Feed Assembly, 3" Cutting Head (62659)

Manual Page Number	Revision

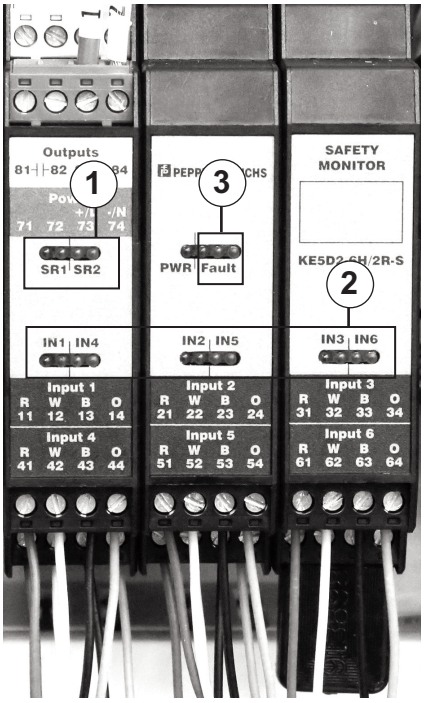
Safety, Safety Switch System Test: The electrical enclosure as currently supplied uses a safety monitor instead of an amplifier. The safety system test procedure is the same; refer to the entry on the previous page for information on the safety monitor. Perform the safety switch test **daily**.

Locations of Sensor Leads on the Safety Monitor					
Switch Number	**1**	**2**	**3**	**4** (Grease Spindle Only)	**6** (Oil Mist Spindle Only)
Guard	Belt Guard	Upper Cutting Enclosure	Feed Hopper	Rear Guard	Oil Pressure and Level Switches
Switch Input	IN1	IN2	IN3	IN4	IN6

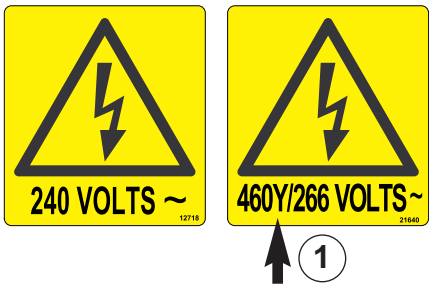
Installation – Electrical Power:
add to Step 1: A machine with a hazard alert label with a ***"Y" (1)*** in the voltage designation contains mini circuit breakers (MCBs) and requires a Wye power supply. To check for a Wye power supply, first calculate the voltage to ground by multiplying the supply voltage by .577. Next, measure the voltage at each phase to ground and compare to the calculated value.

For example, at 400 volts, a Wye supply will measure approximately 230 volts from one phase to ground (400 x .577). One phase may read 0 volts, which is acceptable. A Delta supply at 400 volts will measure 400 volts from one phase to ground. If the machine is supplied with mini circuit breakers or the label designates a Wye power supply, and the voltage from one phase to ground exceeds 277 volts, contact an Urschel service representative.
